TOWN OF KITTERY

ITEM 2—5 Whipple Road—Major Site Plan — Final Review

OVERALL SITE PLAN
 MAINE MEAT BUTCHER & RESTAURANT
 5 WHIPPLE ROAD, KITTEERY, MAINE

SITE DETAILS
MAINE MEAT BUTCHER & RESTAURANT
5 WHIPPLE ROAD, KITTERY, MAINE

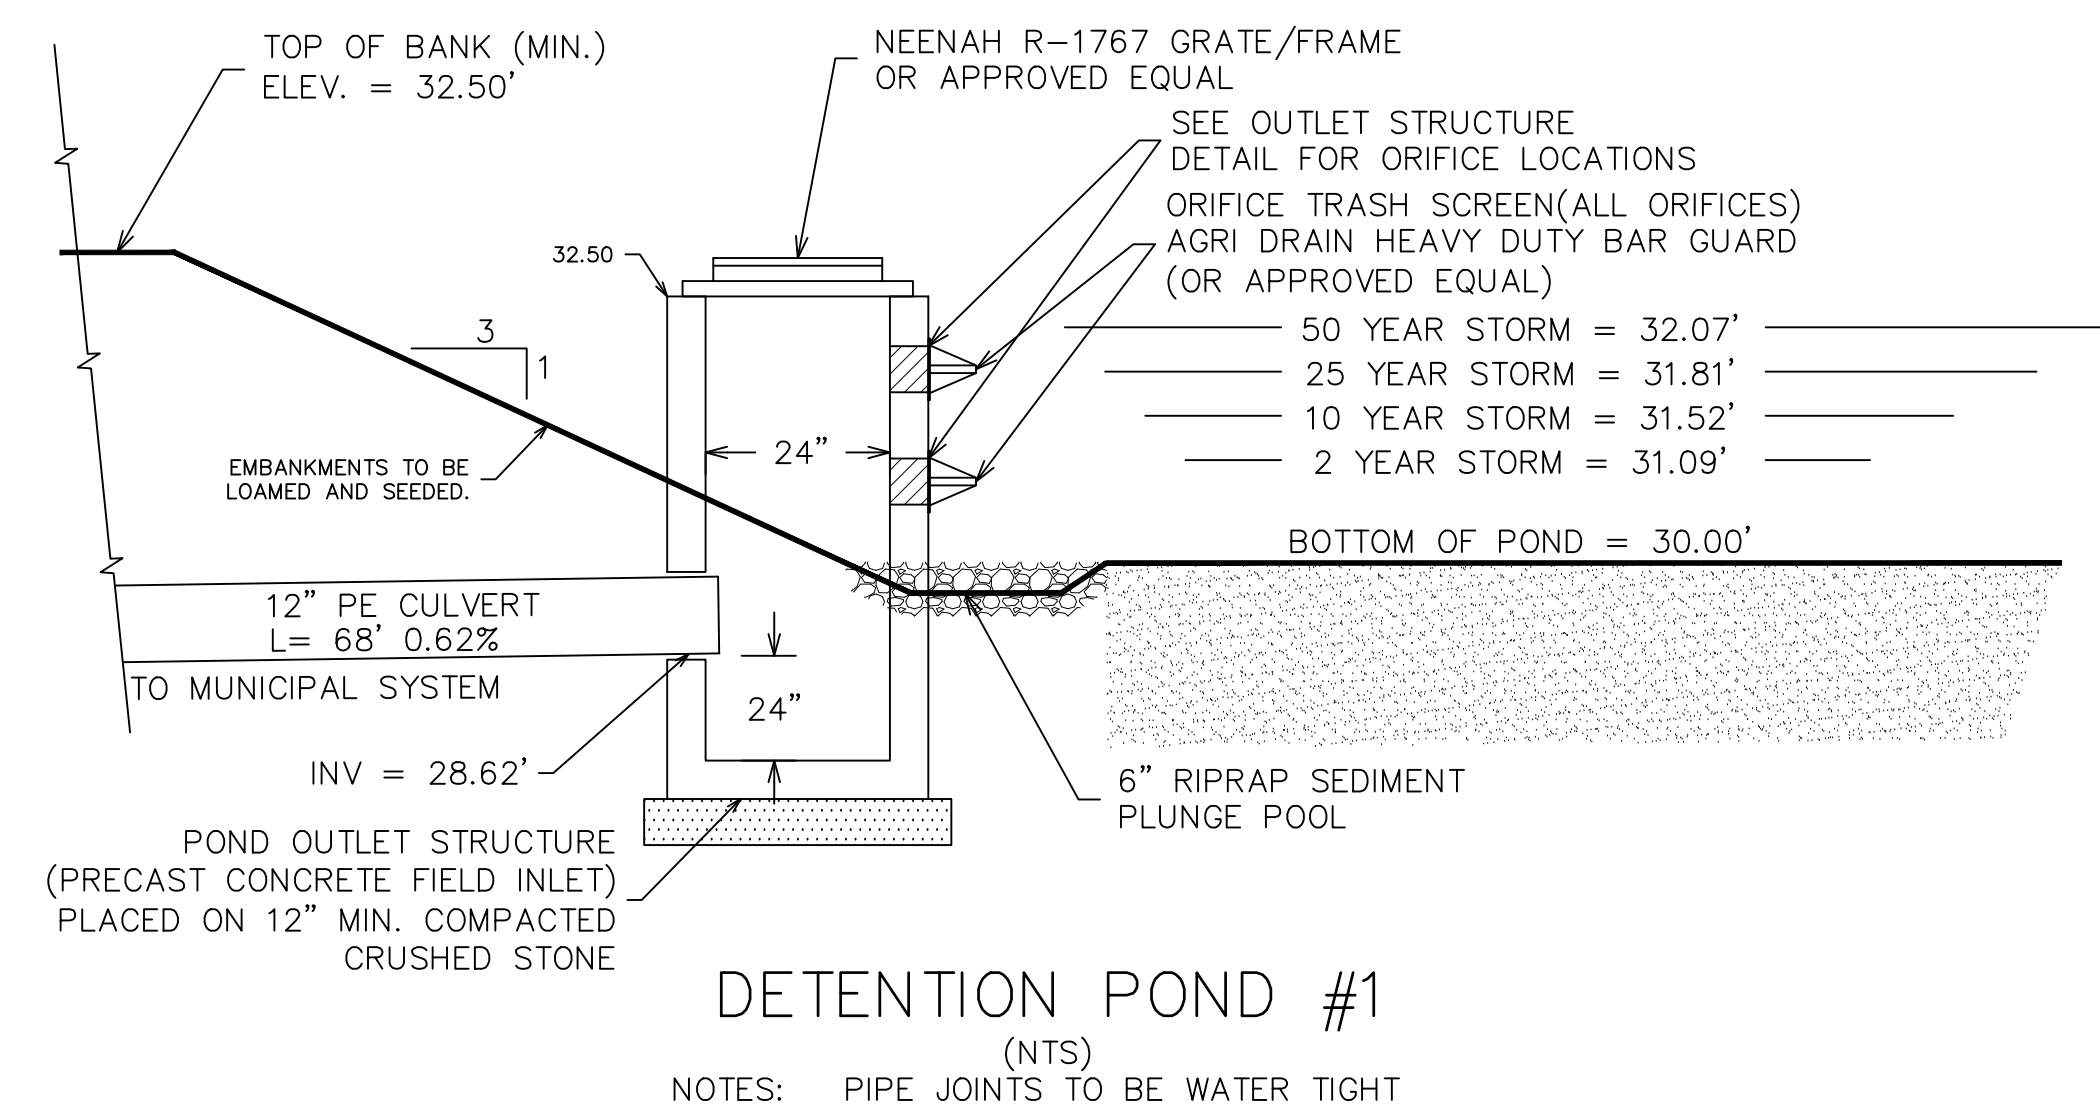
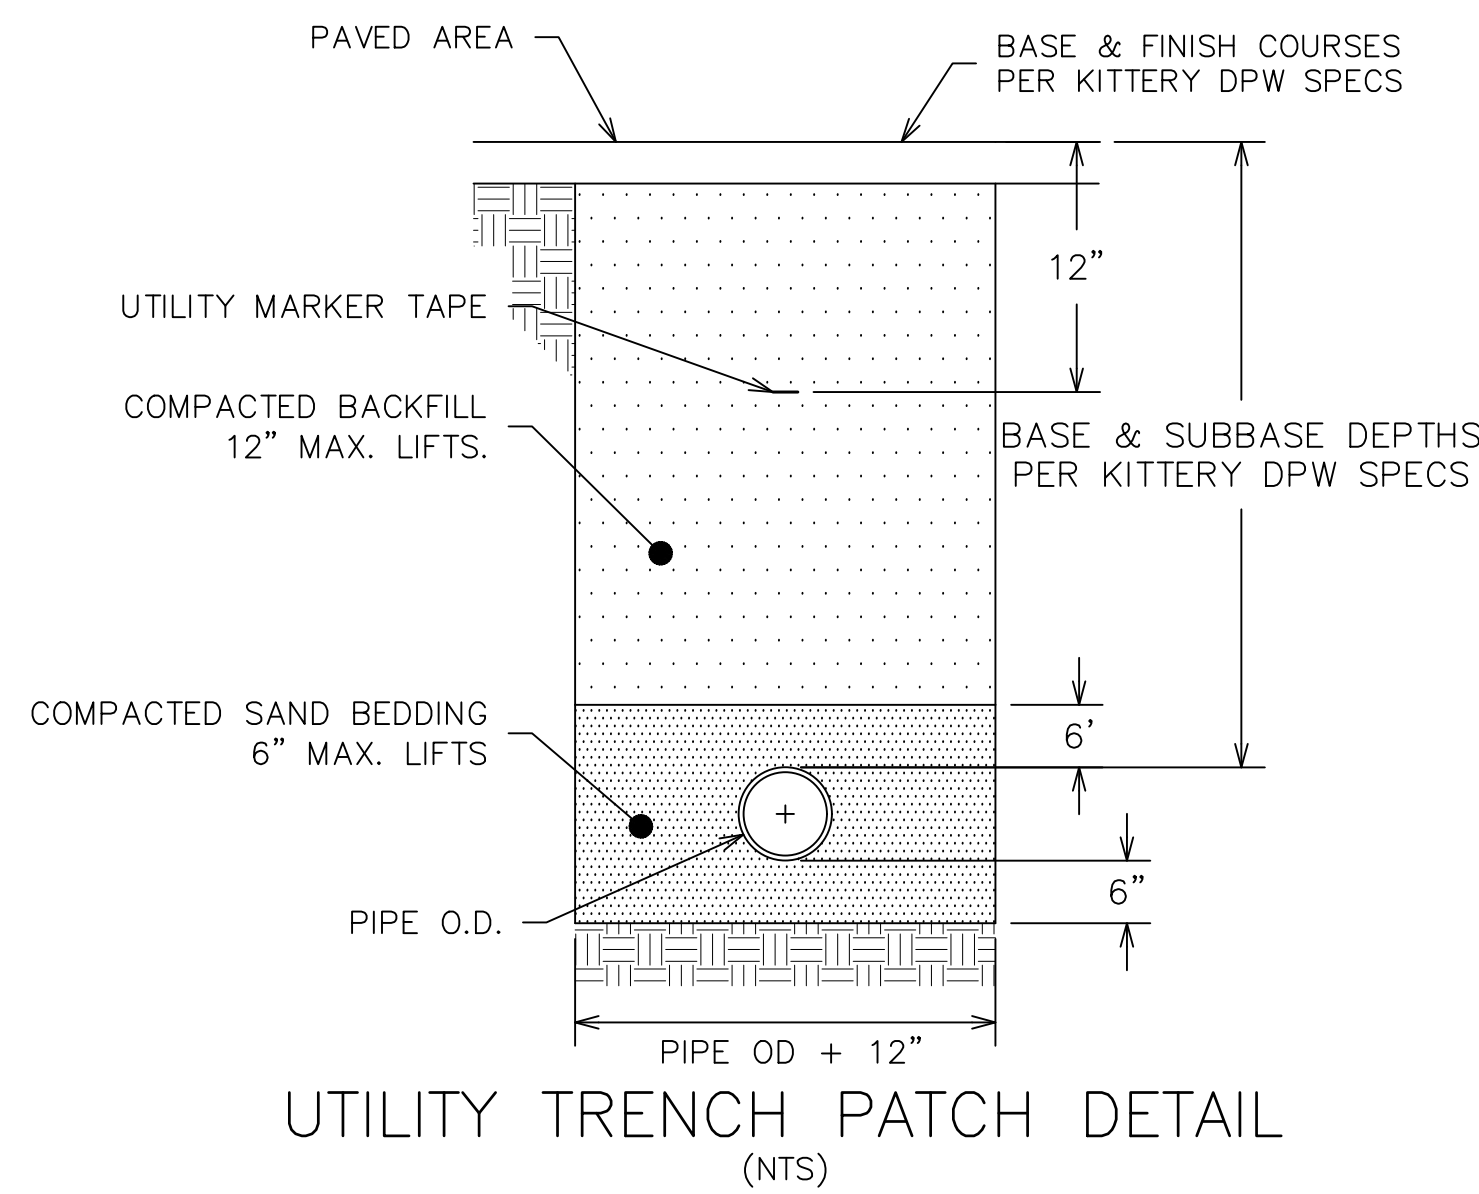
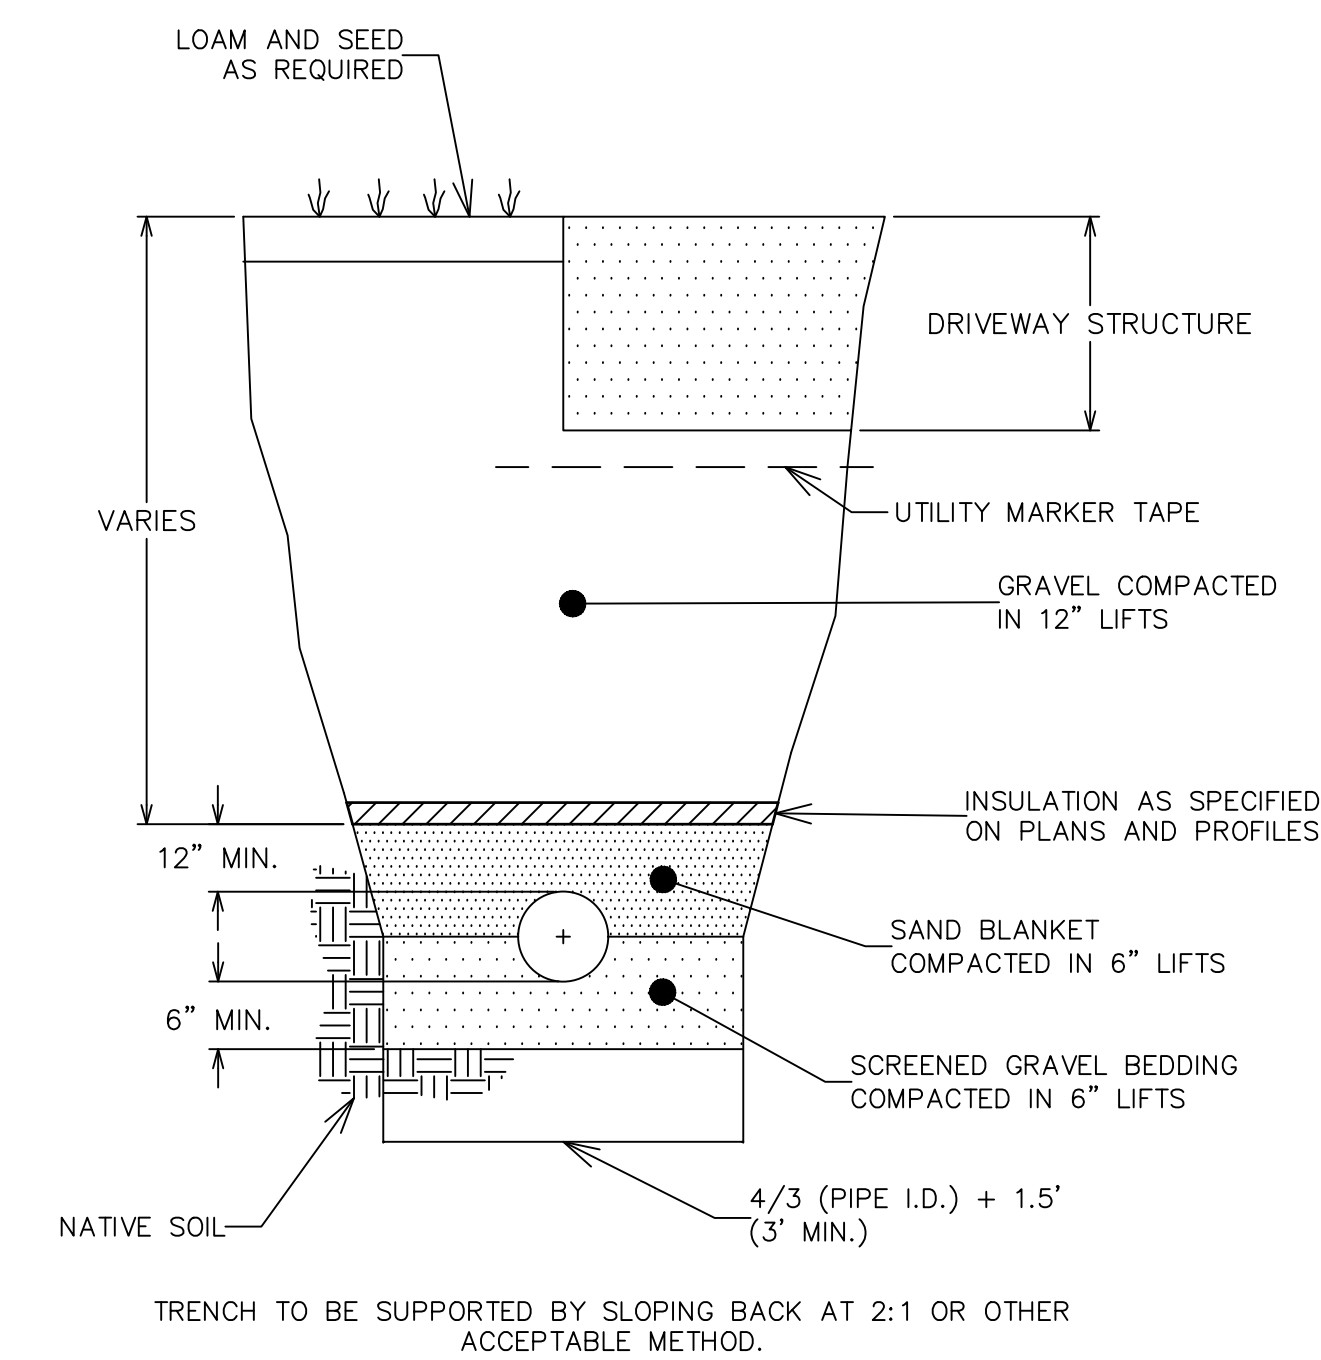
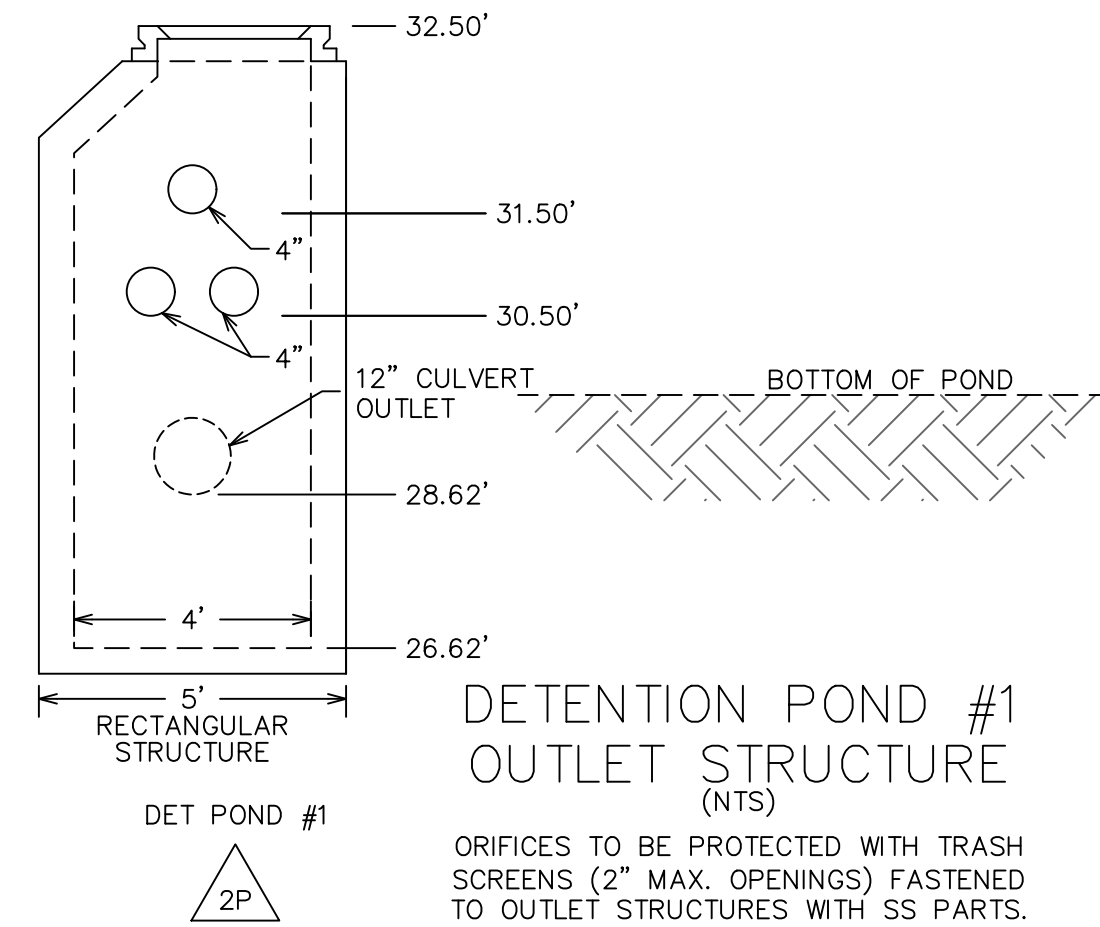
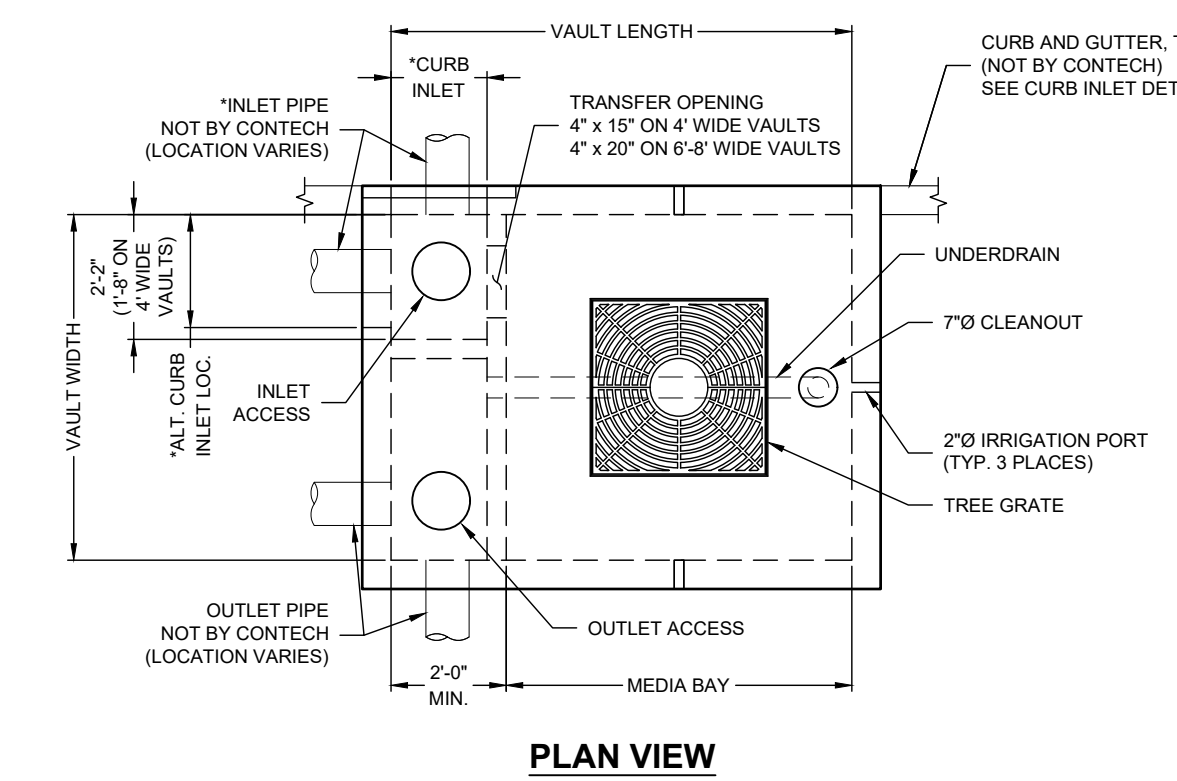
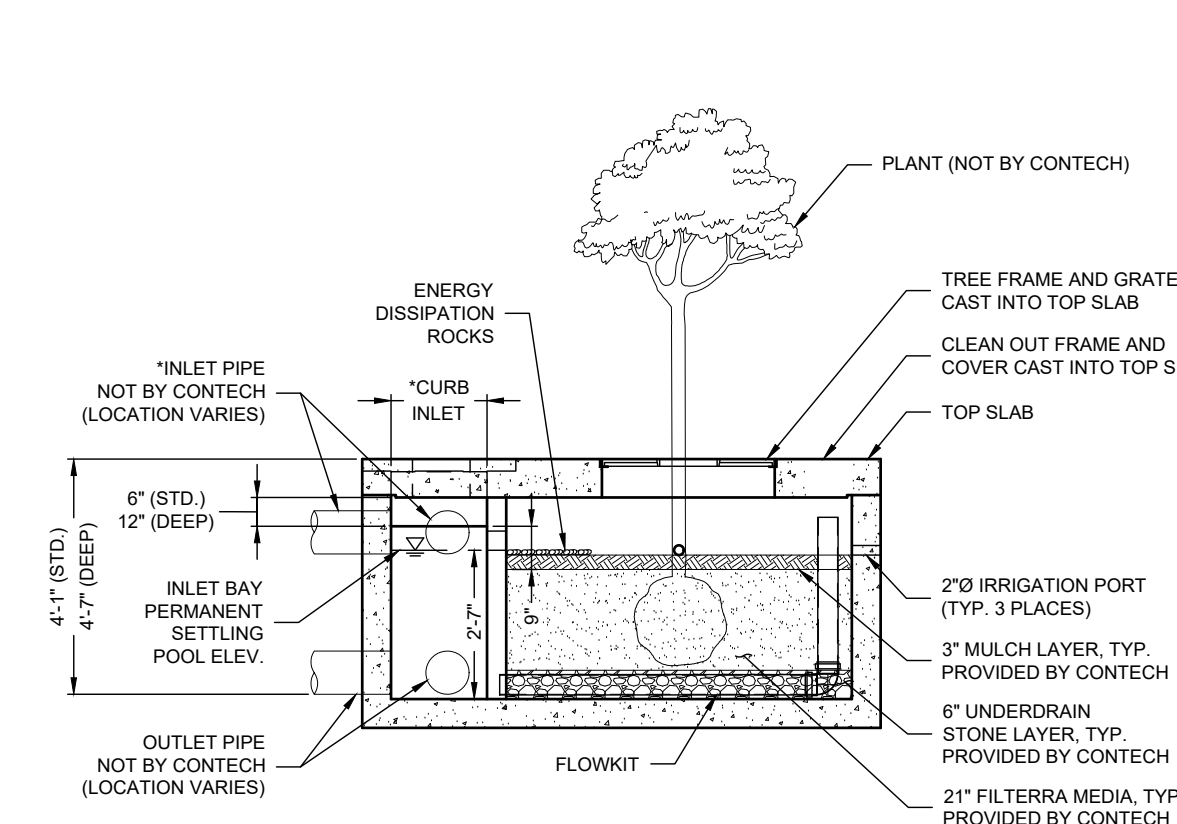
- Sheet #6 (Site Details) has been revised and expanded into a second page (Sheet #7) to include all necessary items; water details, sewer details, travelway and sidewalk information, ADA parking space and loading bay, and new stormwater details associated with the detention basin and overflow control structure.

- Sheet #3 has been revised to include the location of erosion and sedimentation control measures to be installed around the site.
- Sheet #7 (Site Details) has been revised to include Filterra details previously provided in a separate cut sheet outside of the Plan Set.
